## *SPECIAL PLANNING COMMISSION AGENDA*

RE: **Site Plan Review and Special Land Use – 7462 N McKinley Road**

**RE: Draft Response Letter and Revised Site Plan  
7462 North McKinley Road, Flushing, MI  
ERG Project No. 9654**

## REVISED SITE PLAN

SITE PLAN  
SCALE: 1" = 20'

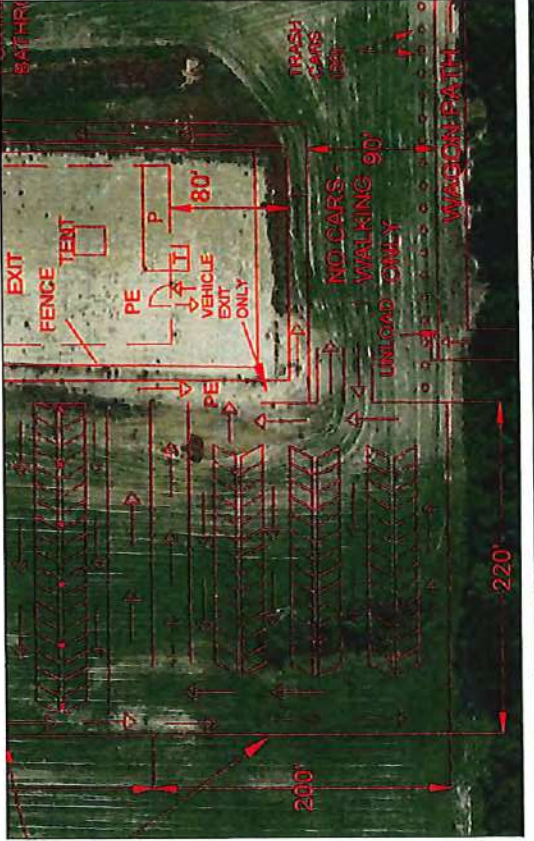
- Section 20-1092(k) – Provide location, intensity, and orientation of all lighting.  
*Drawing 4 has been modified to show the locations of the portable parking lighting. None of the lamps to be used are permanent. Details on the intensity is provided on the drawing. Additional solar powered lights are used near the wagon loading and unloading and bathroom areas for safety.*

MICHIGAN'S HAUNTED HAYRIDE  
 7462 N MCKINLEY, FLUSHING, MI 48433  
 DRAWING PURPOSE: (POND, ETC.)  
 SITE PLAN BLOWUP (1)

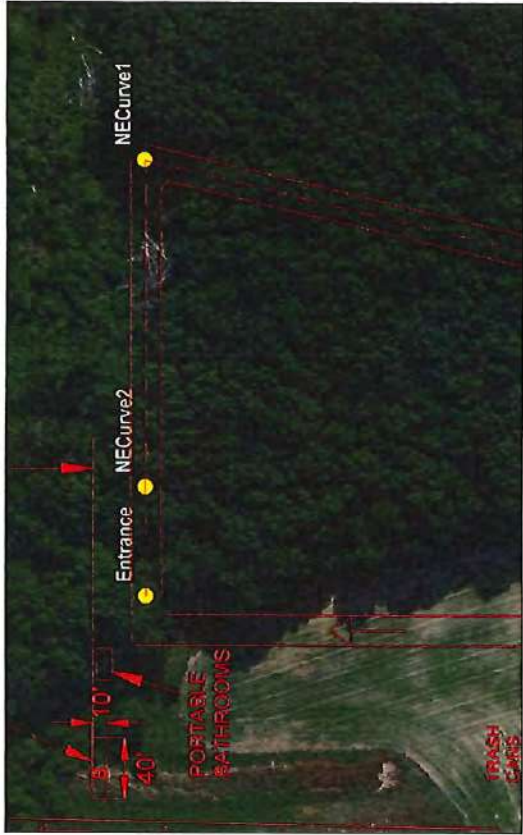
- Section 20-1902 – Site plan needs to be drawn to 1 inch = 20-foot scale.  
*Two additional sheets were included with the scale increased for improved readability. The new drawings at the 20 scale are provided as Drawings 5 and 6.*
- Section 20-1902(d) – Parking space and vehicle maneuvering lane dimensions were not provided.  
*The prints are drawn to scale so the land and parking space dimensions can be measured from the prints. Based on the revised prints provided with this letter, the vehicle parking spaces are 11.1 feet wide, the maneuvering lanes within the parking lot area are 20 feet wide, and the access one-way drives from the road to the parking lot and back to the road (all one-way travel) are 15 feet wide.*

- ~~Sec. 20-1902 A site plan drawn to a scale of one inch equals 20 feet, and at least two copies of this site plan shall be submitted to the township clerk. The site plan is drawn to a one inch equals 70 foot scale.~~ **Addressed. See Sheet 5.**

**MICHIGAN'S HAUNTED HAYRIDE**  
 7462 N MCKINLEY, FLUSHING, MI 48433  
**PROP 1 DEATLS**

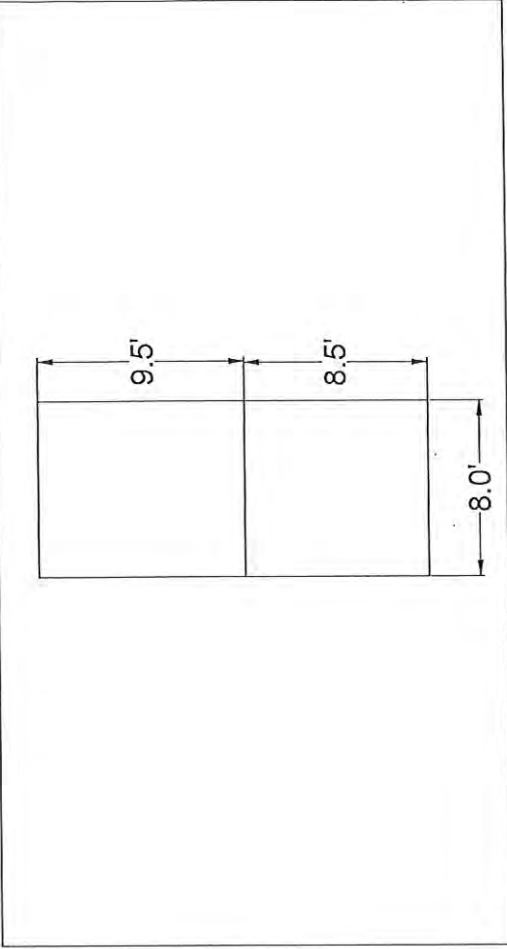
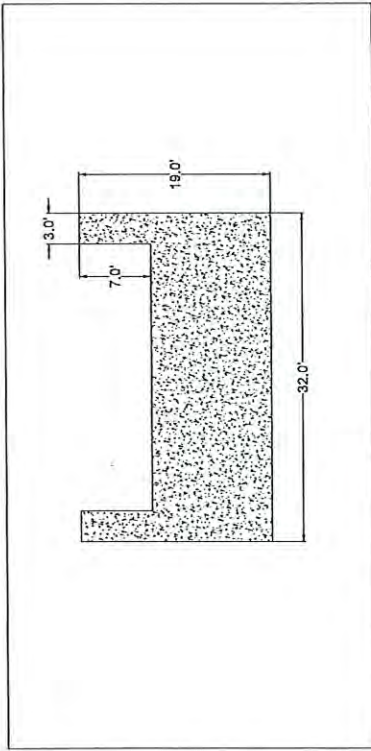
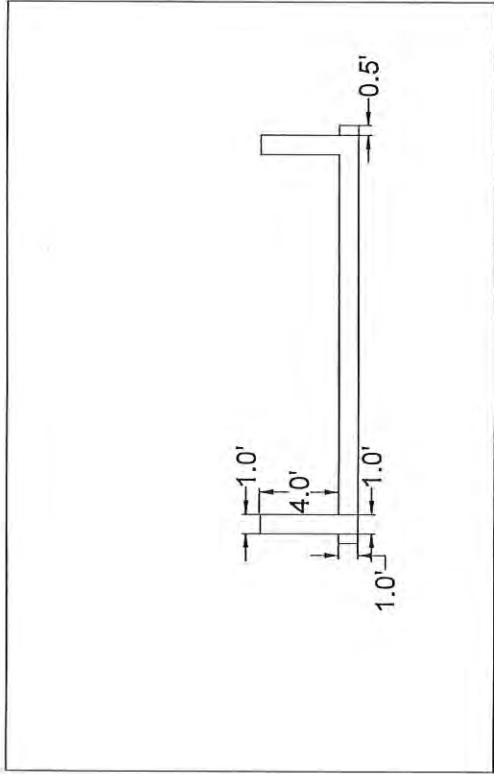
- Section 20-1092(h) – Provide front, rear, and side elevations for any accessory structures.  
*The common definition of an “accessory structure” is a permanent subordinate structure located on the same lot whose use is clearly incidental to and associated with the principal structure, and clearly and customarily related to the principal structure or use. Examples of typical accessory structures include a detached garage, garden and tool sheds, and playhouses. For purposes of this special use permit, offering hayrides is allowed on agriculturally zoned property, and the entertainment props/accessory structures discussed in 1920 (g) above are directly related to the hayride. However, unlike the example accessory buildings listed above, the MHM structures are not inhabitable by people as they have no doors or windows at ground level. ERG’s Site Plan drawings have been revised to include the prop dimensions (see Drawings 7 and 9).*

Sign Details: Front View

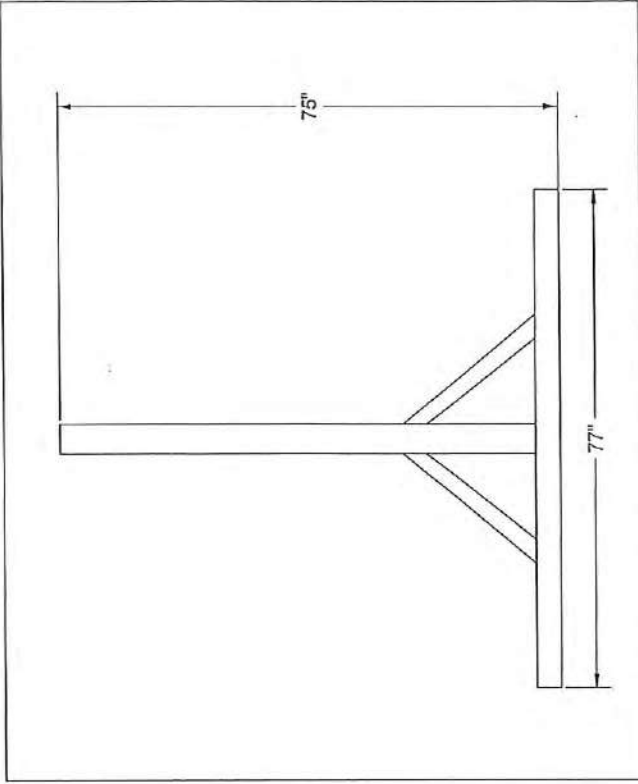
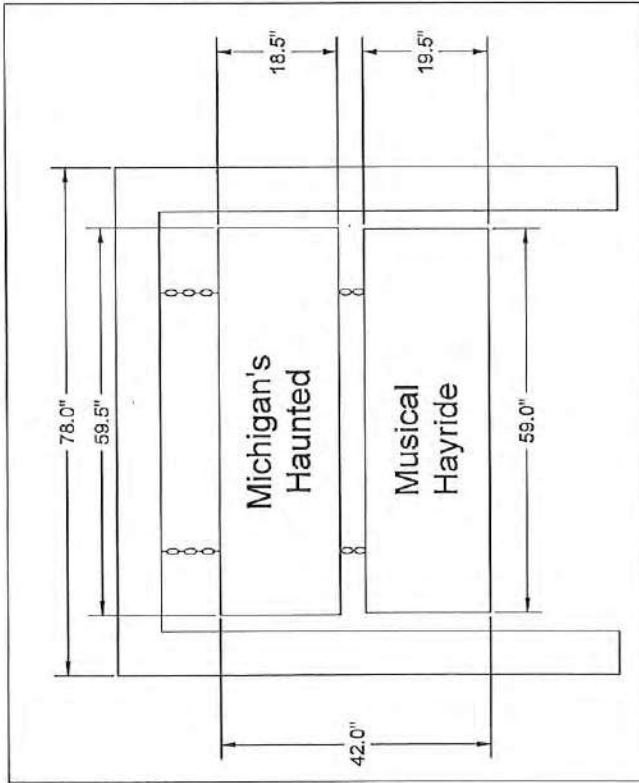
- Section 20-1902(j) – Provide locations, dimensions, and lighting of all signs.  
*MHM intends to install one non-permanent sign, 140 feet south of the road centerline, to note the entrance driveway. This sign will be removed after the special use permit operational period ends. Details on the sign size and lighting is provided in the new Drawing 11. The business intends to use dozens of other on-site pedestrian and vehicle directional signs, to assist with people and traffic movement, ticket sales, food tent, and bathroom location, and for the safety of all patrons. None of these other signs will be lighted, other than ambient light from the portable lamps.*
